APPLIES TO: This technical service bulletin applies to certain model year 2017 through 2019, K2 model motorhome chassis built between November 8, 2016 and December 3, 2018.

CONDITION: Shocks may allow for a ride that is considered to be too soft.

CORRECTION: Replace shocks

FIG. 3-1

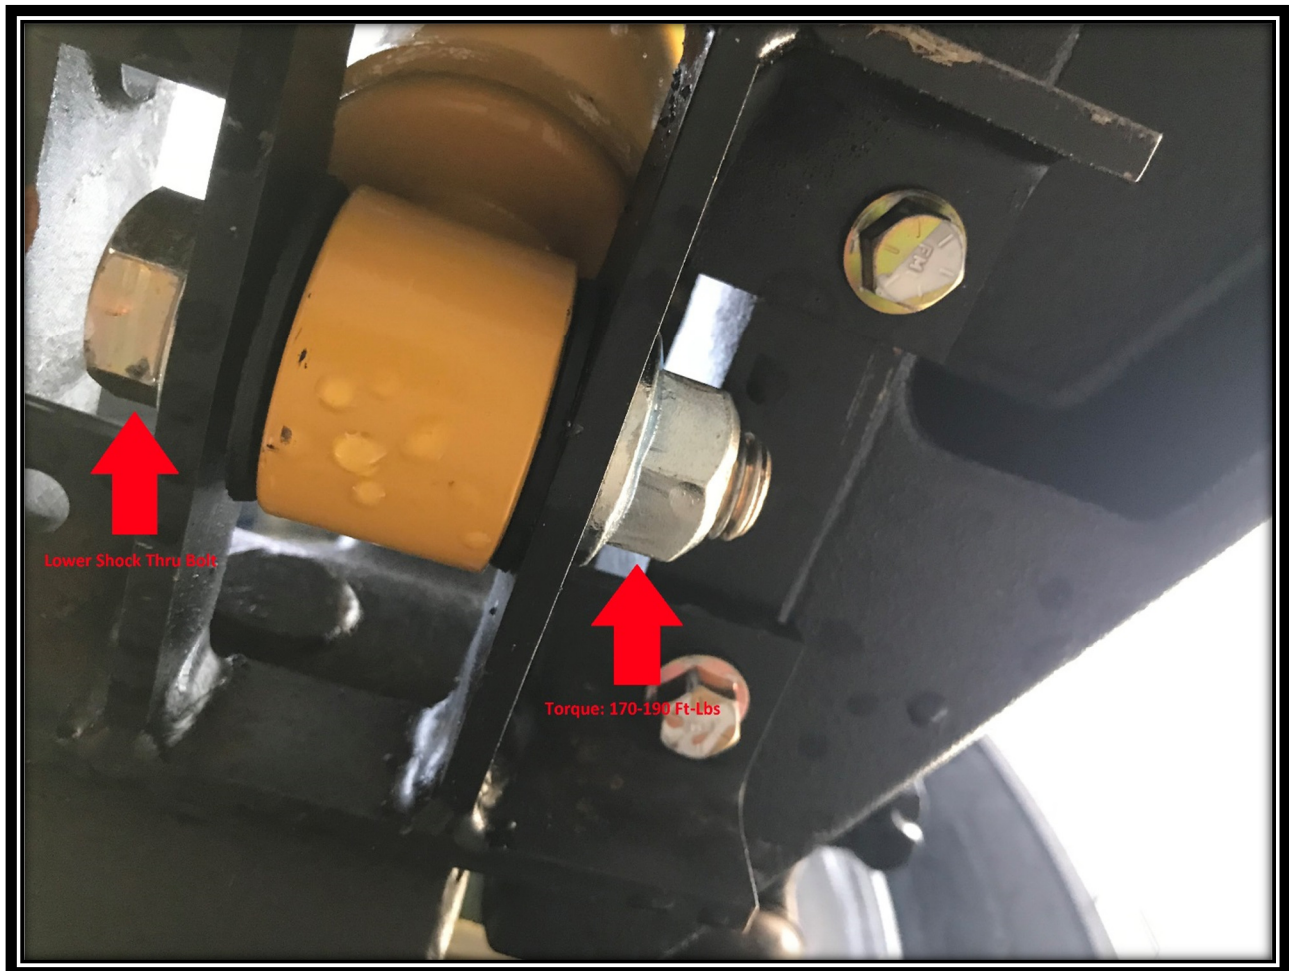
5. Repeat steps 1-4 on opposite side.
6. Install shock such that lower thru bolt can be installed through shock mounting eye. Refer to FIG. 3-1.
7. Reinstall retained lower thru bolt. Refer to FIG. 3-1.
